**PROPOSAL FOR DRAFT AMENDMENTS (SUPPLEMENT 5) TO THE 02 SERIES OF
AMENDMENTS TO REGULATION No. 101**

(Emissions of CO₂ and fuel consumption of M1 categories of vehicles)

Transmitted by the expert from France

Figure 8/1: Parameters measured during carbon dioxide emission and fuel consumption test during and between cycles where regeneration occurs (schematic example, the emissions during 'D' may increase or decrease)

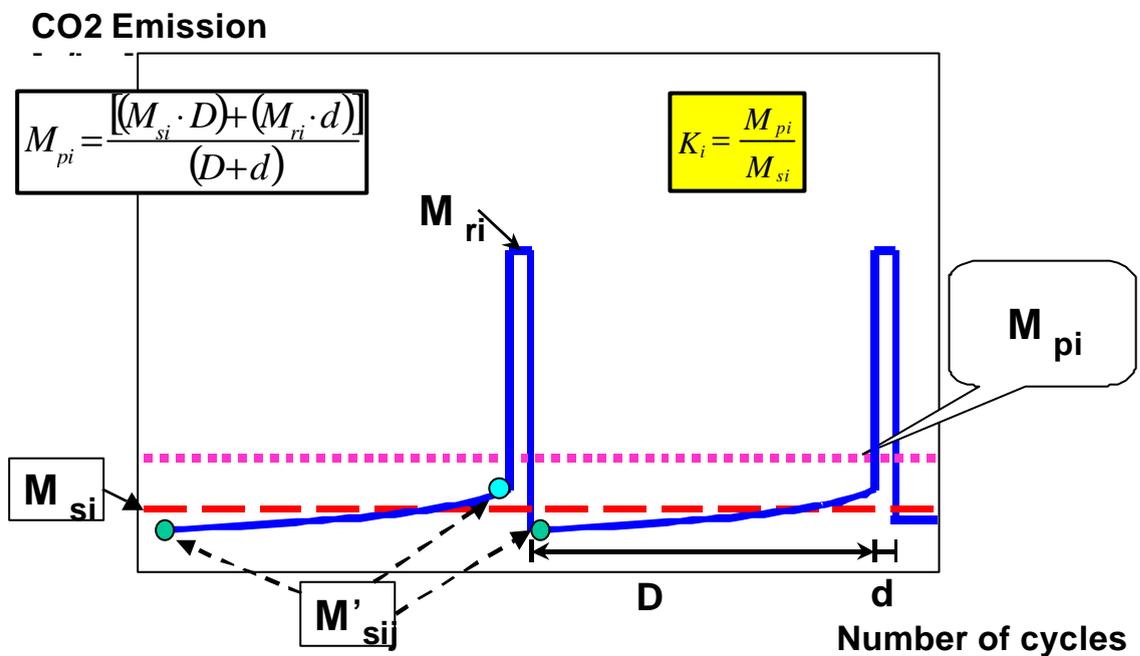
For exemplary illustration of measurement parameters see figure 8/1.

3.4. Calculation of the regeneration factor K for carbon dioxide emissions and fuel consumption (i) considered

$$K_i = M_{pi} / M_{si}$$
